Response to 103 Rejections of Claims 40-57

This confirms receipt of:
Amendment Responding to July 24, 2001 Office Action in U.S. Patent Application No. 09/200,495; Request for One-Month Extension of Term; IPTL Check No. 08785 in the Amount of \$110.00 for Fees

In re U.S. Patent of: Advanced Technology Materials, Inc.
Patent Appl. No.: 09/200,495
Filing Date: 25 November 1998
Title: OXIDATIVE TOP ELECTRODE DEPOSITION PROCESS,
AND MICROELECTRONIC DEVICE STRUCTURE
Date Mailed: November 26, 2001
Express Mail Label: EL037732817US
Attorney Ref.: 2771-337 RCE

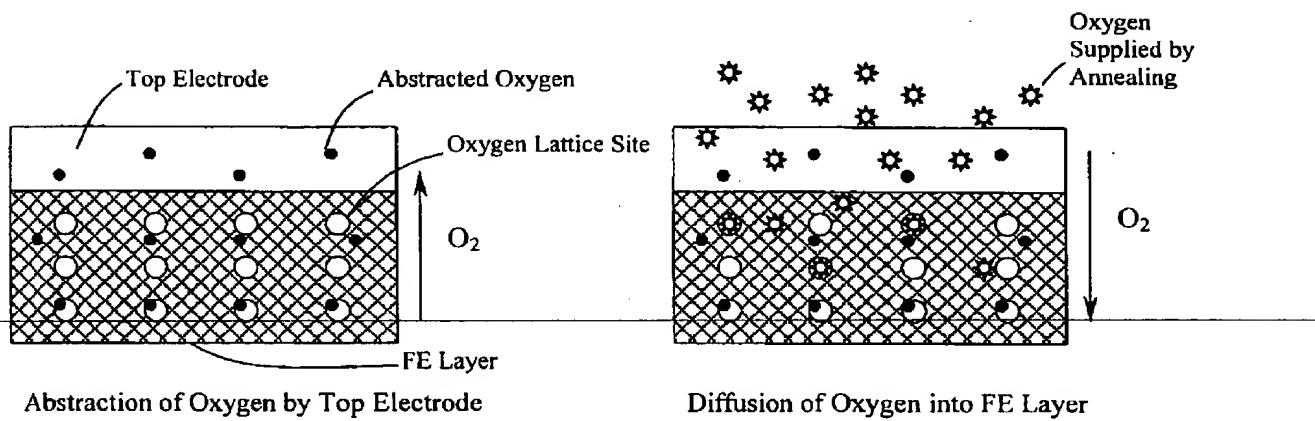
The process disclosed by Nishioka involves an initial loss of oxygen content in the ferroelectric material, and a subsequent diffusion of oxygen from external environment through the upper electrode into the ferroelectric material, as illustrated below:

The initial oxygen abstraction/loss by the top electrode layer, as shown hereinabove, destroys the original lattice structure of the ferroelectric material and leaves oxygen vacancy in the lattice structure. The subsequent supply of oxygen by heat-annealing in an oxidizing environment does not completely restore the original lattice structure in the ferroelectric material and leaves a disordered lattice structure.

Moreover, diffusion of atomic oxygen into the ferroelectric film will necessarily entail the formation of an oxygen concentration gradient in the ferroelectric material film. Therefore, oxygen content in the post-diffusion ferroelectric material will be non-homogeneous in stoichiometry.

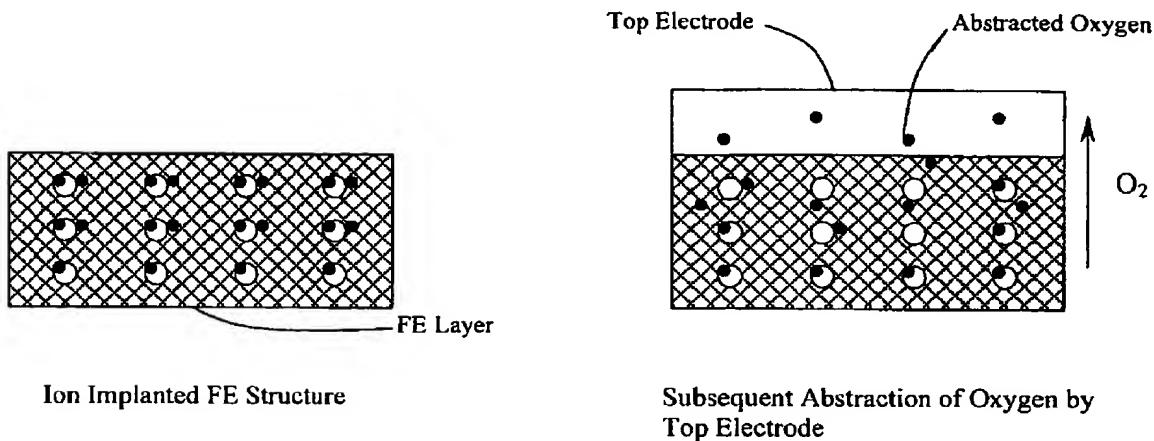
Larson only discloses initial incorporation of excess oxygen in the ferroelectric material layer, which, although it compensates for subsequent oxygen loss, still leaves a disordered lattice structure and a non-homogeneous oxygen concentration throughout the ferroelectric material layer, as shown below:

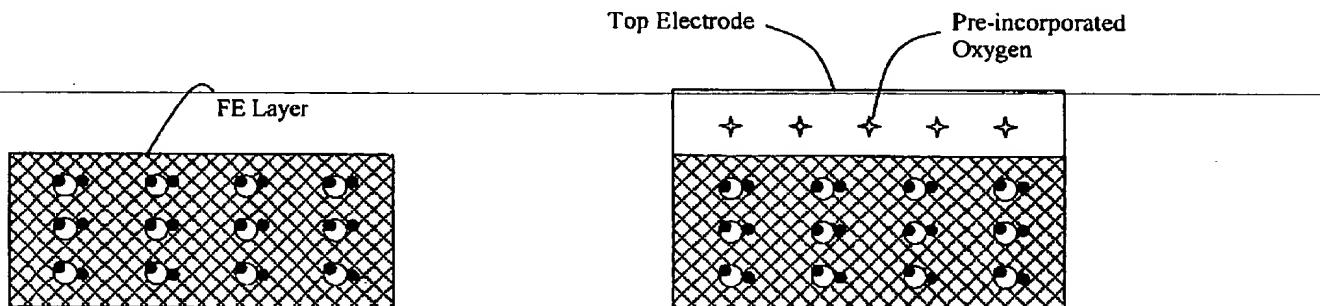
In contrast, applicants' claimed invention, by forming a top electrode pre-saturated with oxygen, prevents abstraction of oxygen by the top electrode, and therefore advantageously preserves the original lattice structure and a homogeneous oxygen content throughout the ferroelectric or high ϵ oxide material, as shown below:
